Appendix 9-2

OPRHP Facility-Related Correspondence

RE: Request for Consultation: Riverside Solar, LLC – Riverside Solar Project

Re: PSC
Riverside Solar/ 100 MW/ 1,067 Acres
Brownville, Chaumont, and Lyme, Jefferson County, NY
20PR03909

Figure 6-1. Site TRC-RS-8 site avoidance plan.

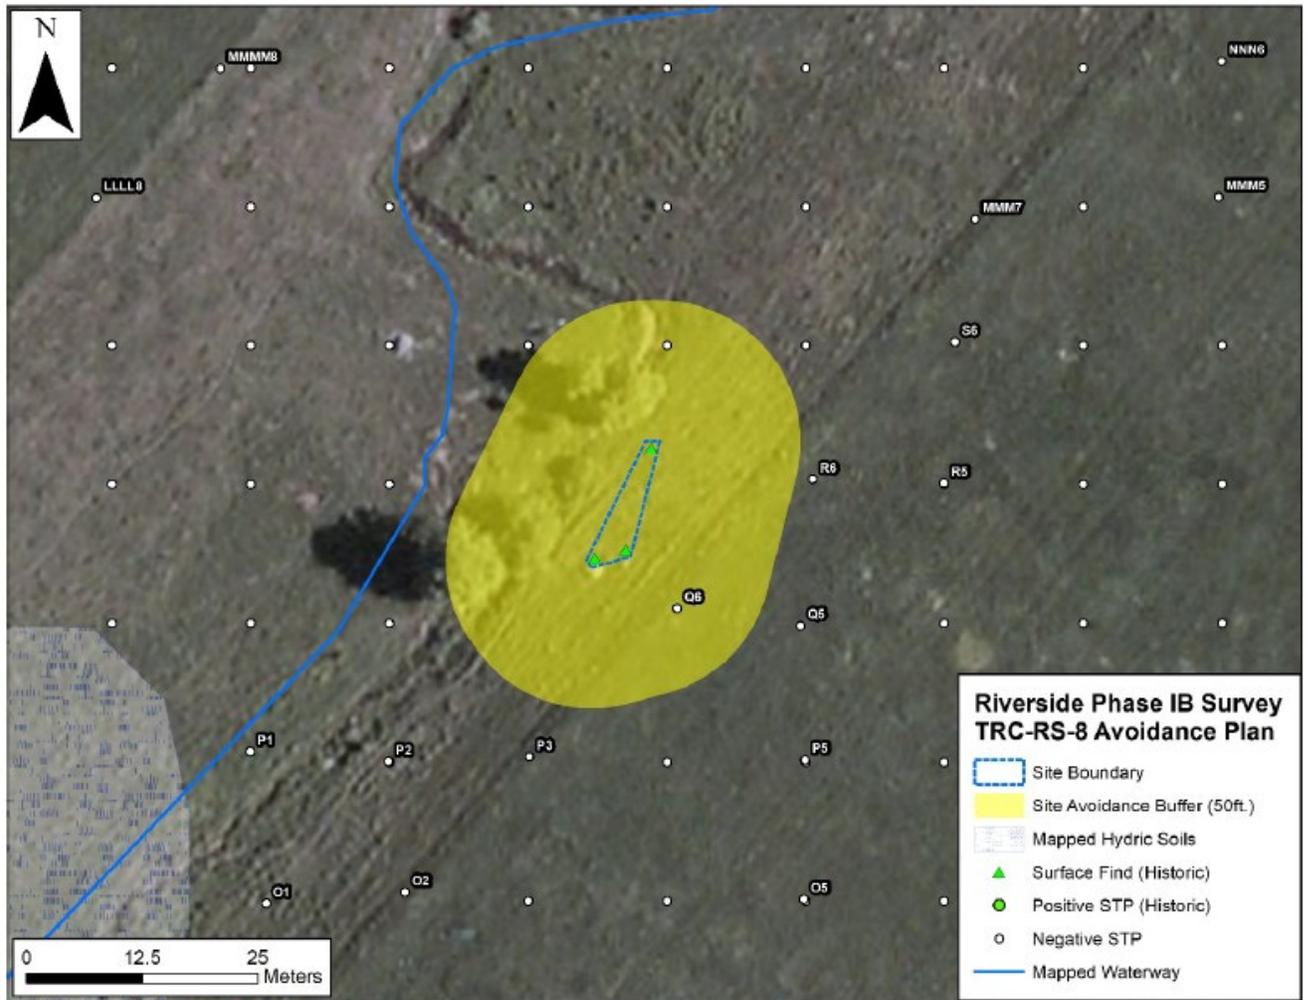
We are refraining from determining if TRC-NS-8 is a site until we have the above noted additional information. If TRC-RS-8 is determined by OPRHP to be an archaeological site, a Site Avoidance plan with the site boundary and buffer zone like that provided for TRC-RS-9 (Figure 3) will be requested.

The SHPO acknowledges that one (1) Historic Site (TRC-RS-8, USN 04513.000202) was identified during the above noted investigation. The eligibility of TRC-RS-8 for the State or National Registers of Historic Places remains undetermined, and thus the site (including a fifty-foot (50-ft) buffer as per the enclosed figure) is to be avoided during construction and the Site Avoidance and Protection Measures noted in the report are to be implemented (see Page 60). If there are inadvertent impacts to Historic Site TRC-RS-8 during construction, the impacts are to be reported to the SHPO immediately.

Figure 5-12. Area perceived by neighbor as possible cemetery location and area examined by TRC for possible cemetery.

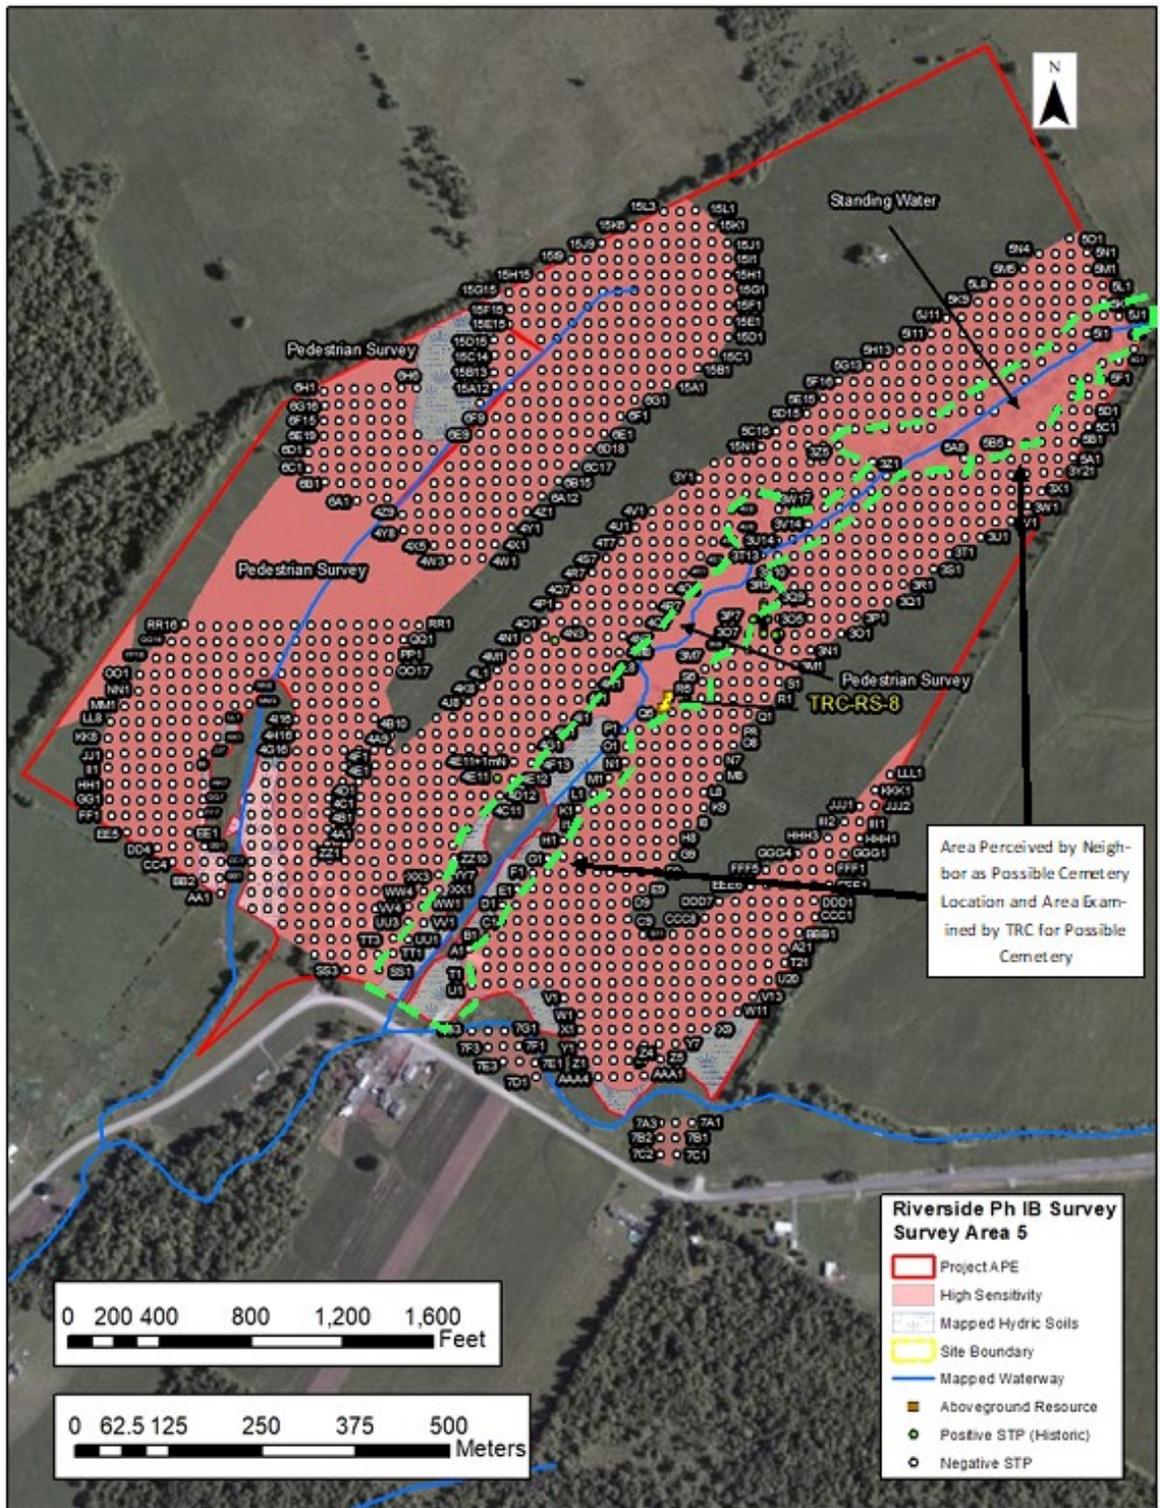
- b. Please provide a map indicating the approximate location and if possible, the extent of the landowner reported unmarked family cemetery within Survey Area 5 (Figure 4-17) and provide photographs of the potential cemetery location.

Additional research conducted by TRC subsequent to the initial reporting of a possible family cemetery within the proposed project's Area of Potential Effects (APE) concluded that there was no corroborating evidence in support of the cemetery's existence. It is the SHPO's understanding that the perceived location of the possible cemetery will be avoided as the area is within a drainage that will not be impacted by construction (see report Figure 5-12, attached herein). If an inadvertent discovery of possible human remains occurs during construction, the SHPO/OPRHP's Human Remains Discovery Protocol (January 2021, Appendix C of report) is to be followed, construction in the area is to cease, the human remains/possible human remains are to be left in the ground and reported to the SHPO immediately.
